Name: Colony Park - Filing No. 2 - Preliminary Plan -SE Patterson & 25 ½

COLONY PARK
PROJECT NARRATIVE

COLONY PARK FILING NO. 2

MODIFIED RYTOUAL METHOD
 CALCULATION OF STORMWATER
 STORAGE VOLUMES
 Q_{10}

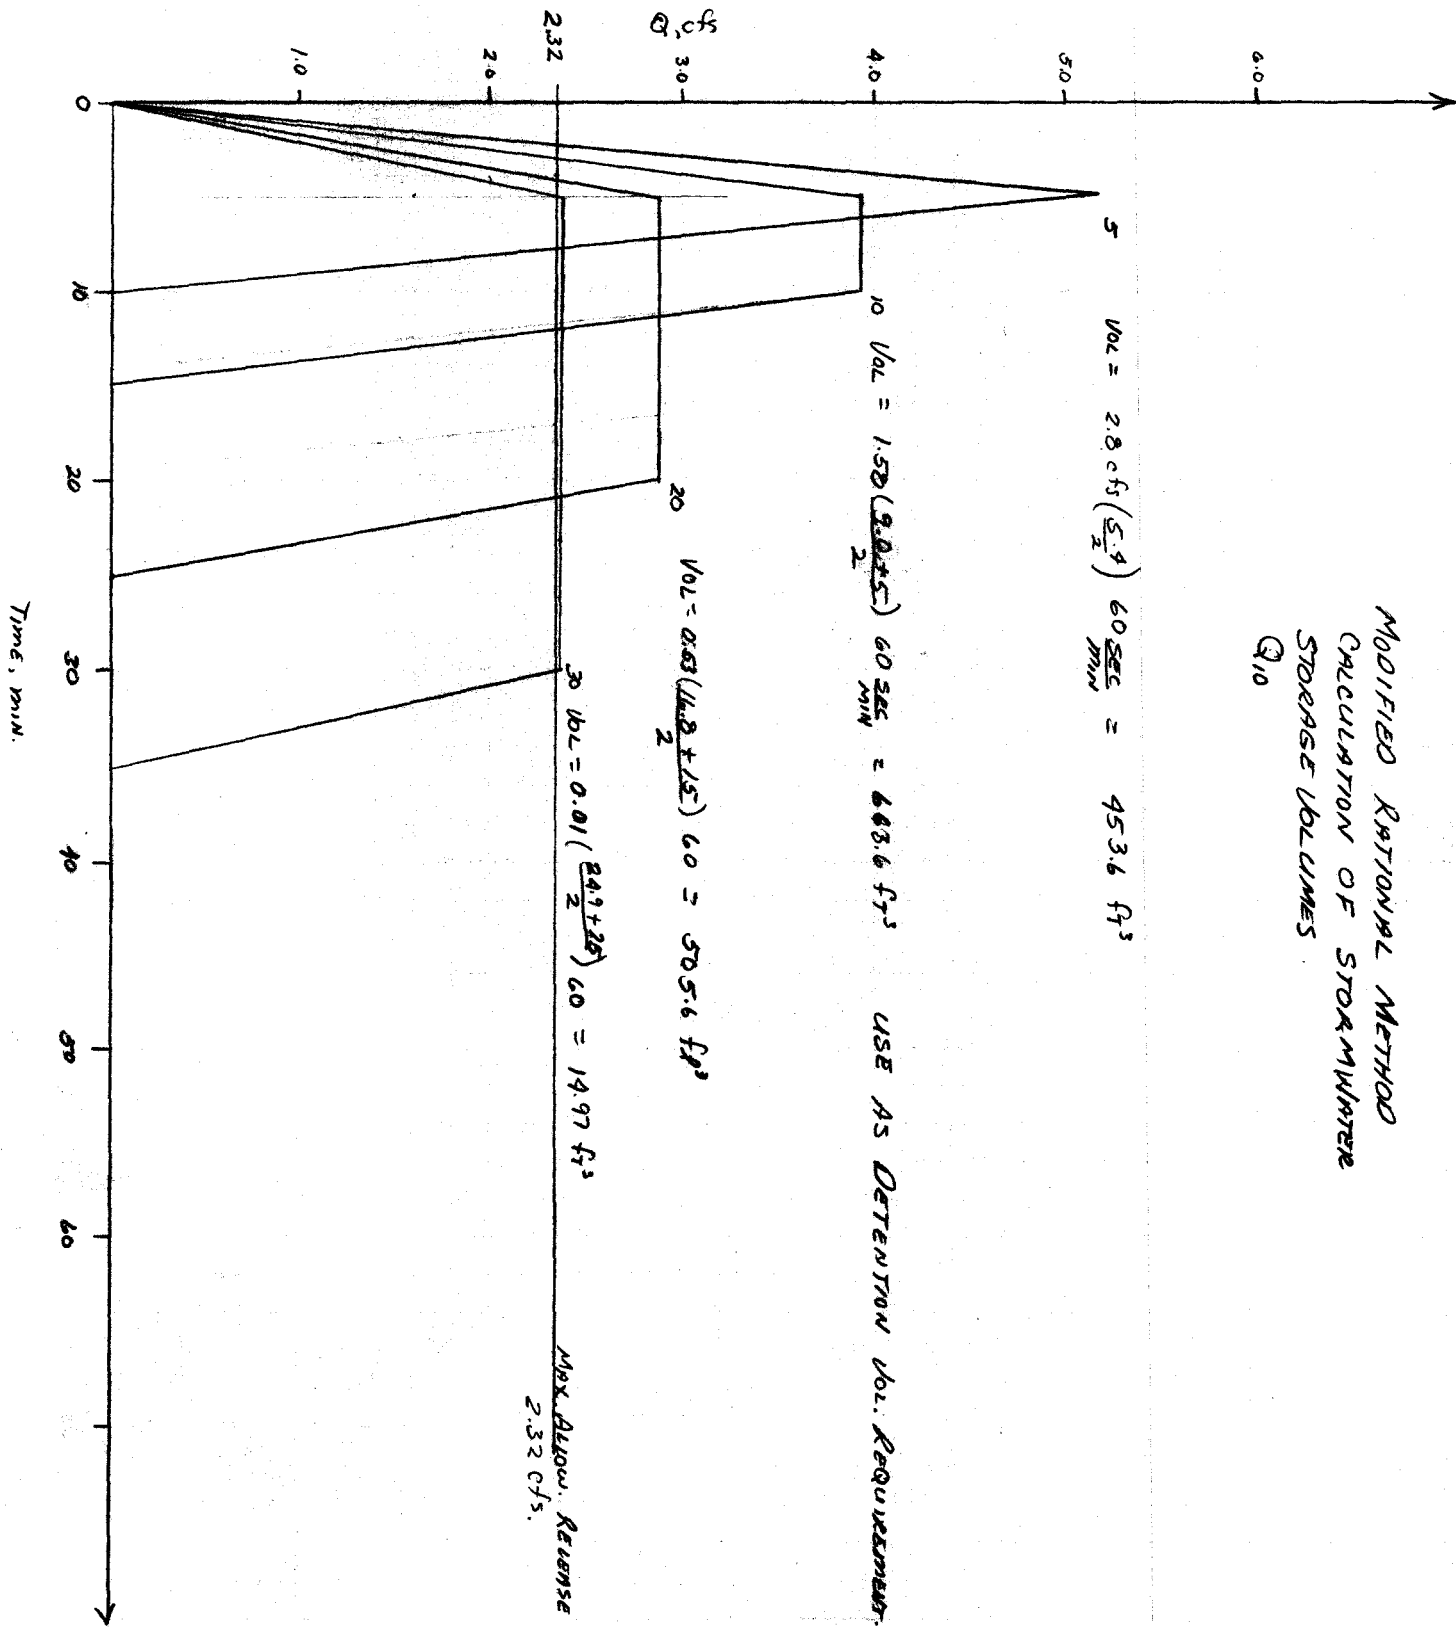
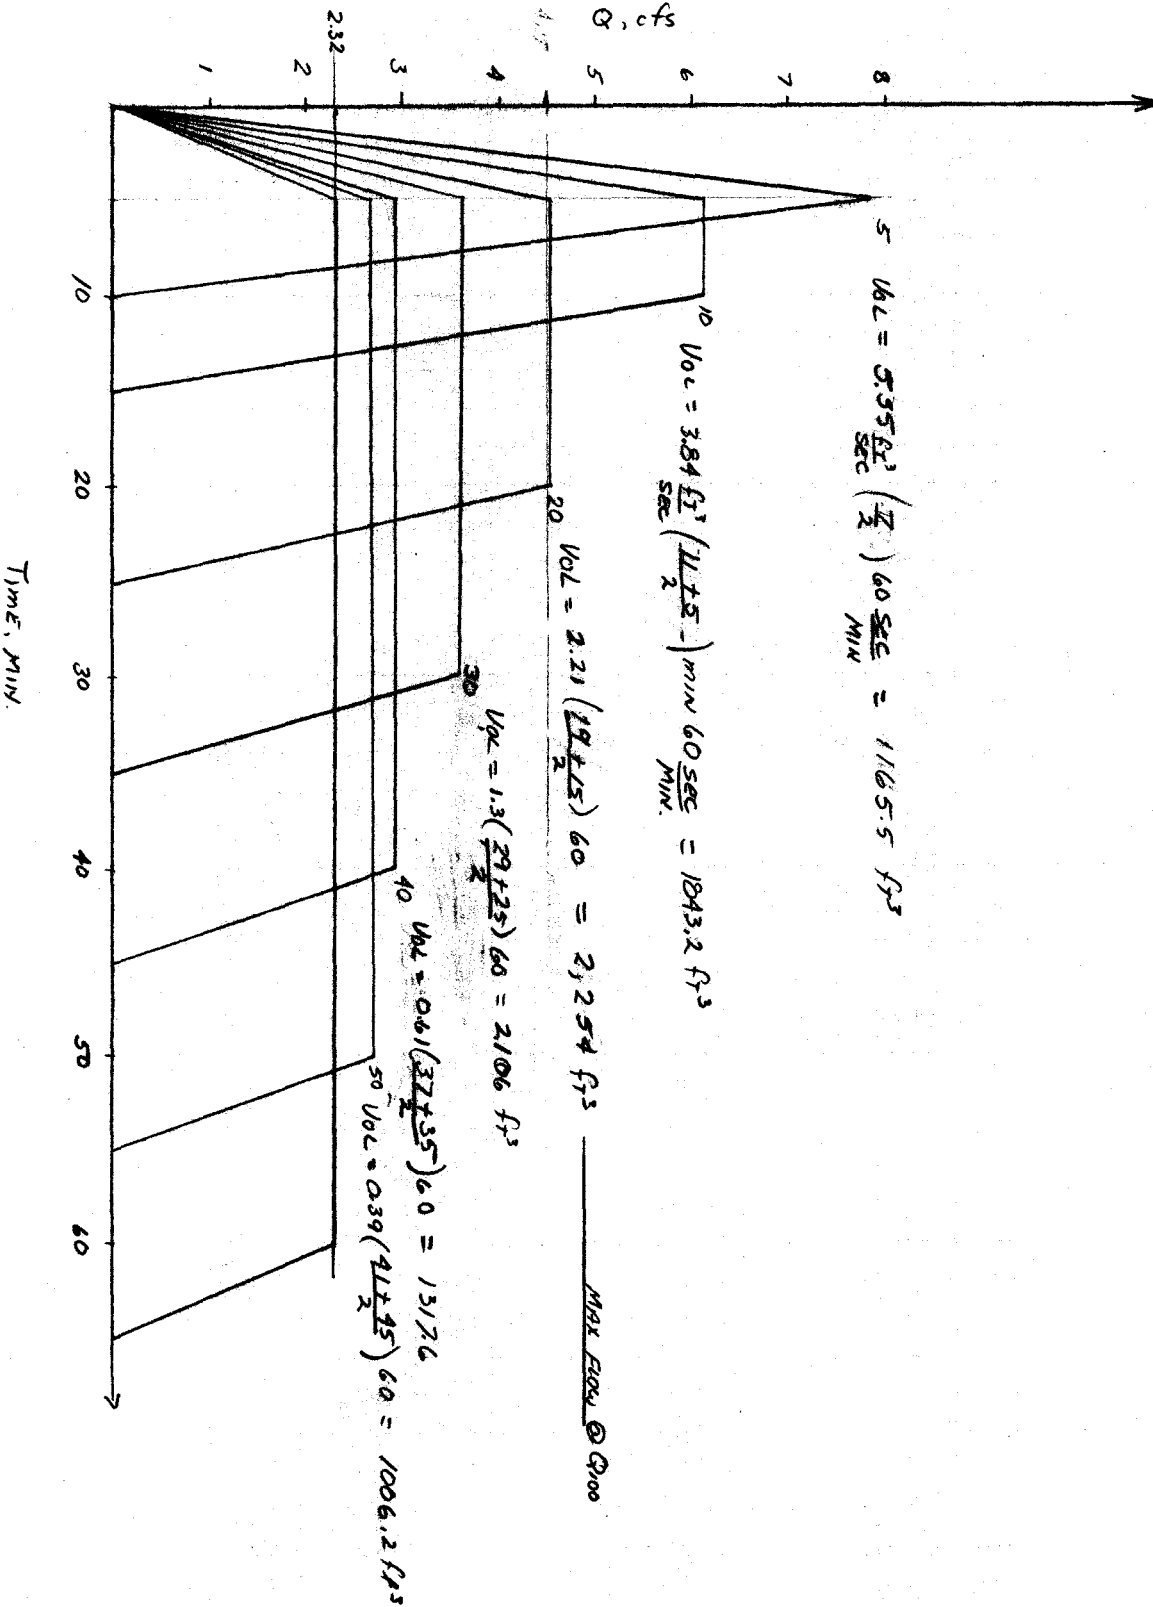
Drainage: In drainage calculation, why is historic discharge from basin 2 not included in allowed maximum release rate? If included, the allowed release rate would increase from 2.32 to 4.97 cfs. I have no objections to the proposed drainage plan and report, however, the storm sewer pipe should be connected to the proposed new drainage pipe to be constructed along the west side of the development. Please call the Grand Junction Drainage District for details.

- 1.) Drainage concern was referred to Banner & Associates and was verified calculations are correct.
- 2.) "EGTC" is clearly marked on legend.
- 3.) A meeting with adjacent property owners was called to discuss traffic circulation of future development on their properties. The consensus was this development would not be the major access to future development of the adjacent property.

ALCO BUILDING
 GRAND JUNCTION, COLORADO
 CIDER MILL ROAD PLAN AND PROFILE
 SCALE: Horiz: 1"=30' Vert: 1"=5'
 DATE: 5-28-91
 Project No: 8239-01
 SHEET No: 7 of 10

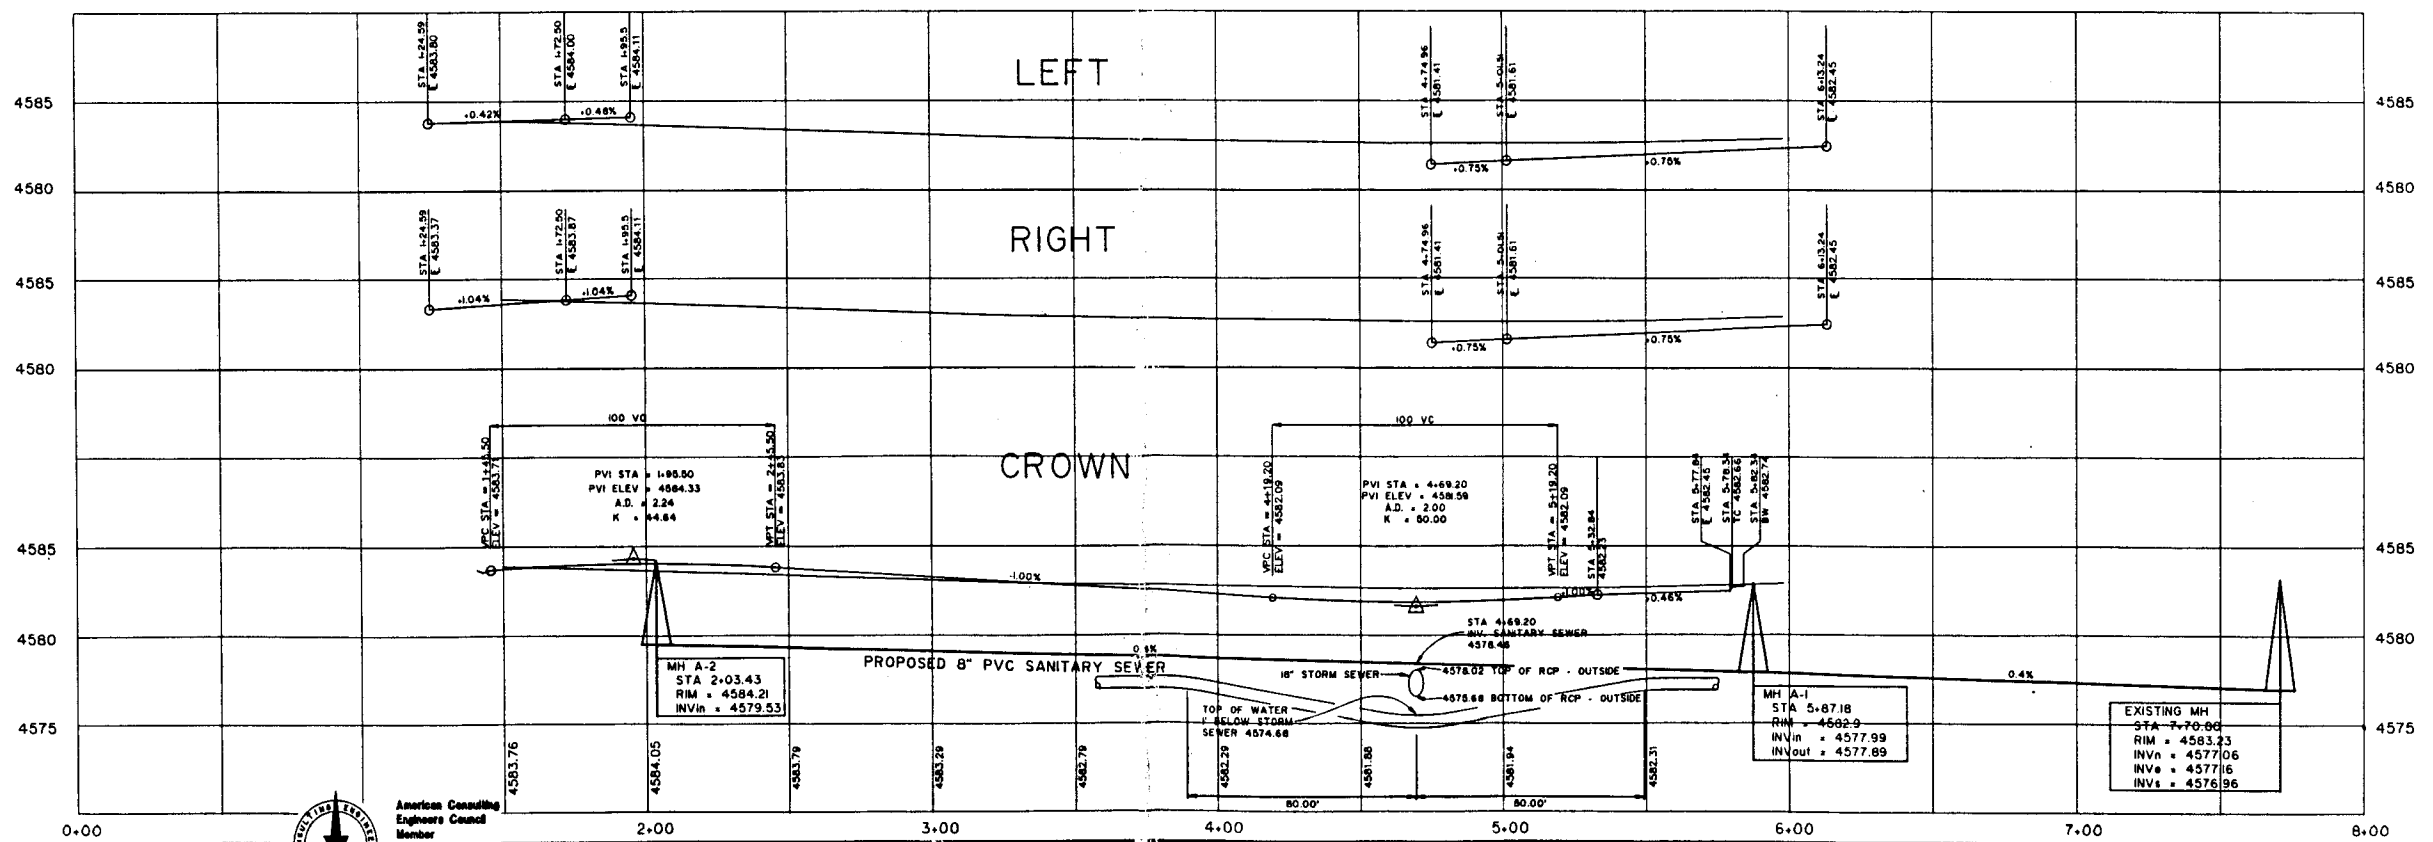
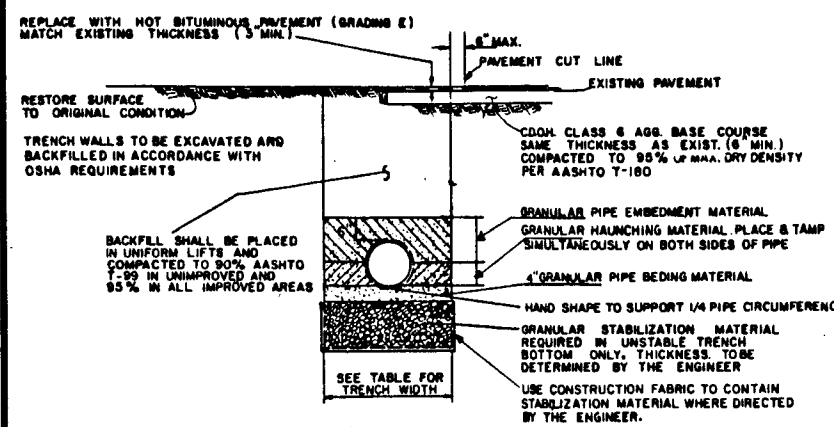
Street: What is the "EGTC" line shown along outside of the right-of-way line on sheet 7?

WATER SERVICE CONNECTION

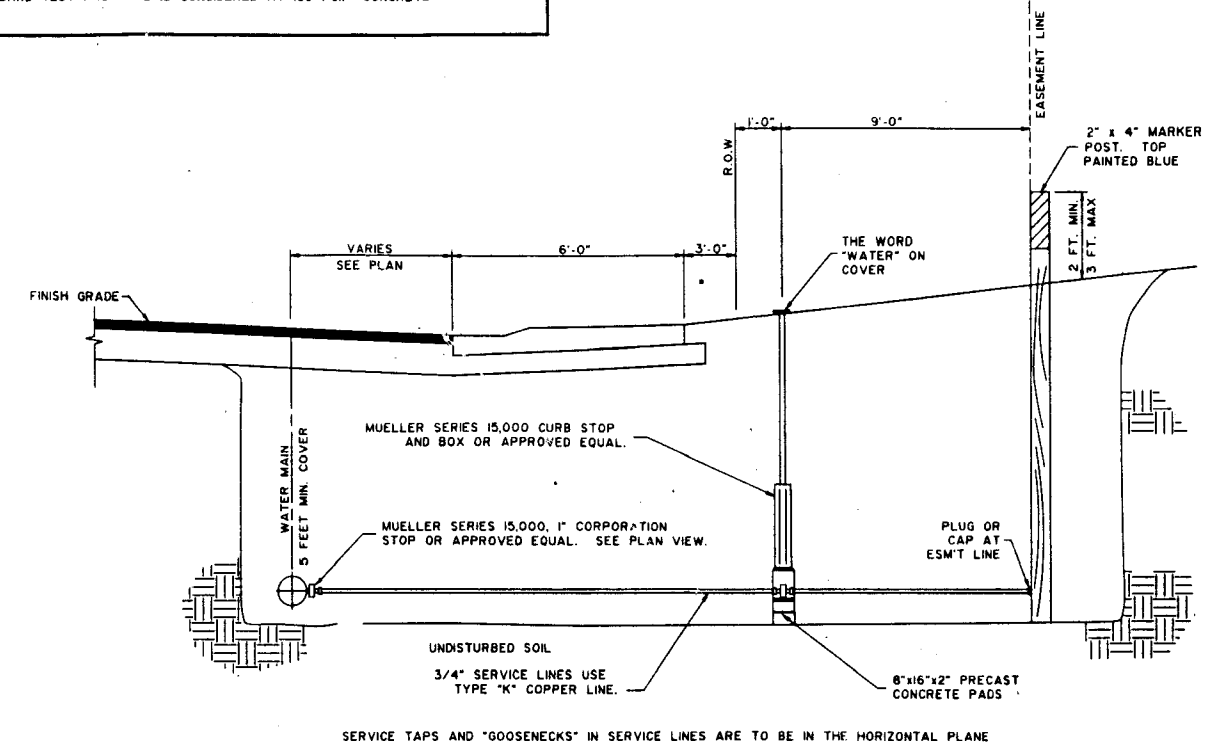
Individual meters would connect to the 8" main on Cider Mill Road. Illustration of the water service connection on sheet 9 of 10 is incorrect. Curb stop valves need removed and a corp stop valve added at the end of the service line.
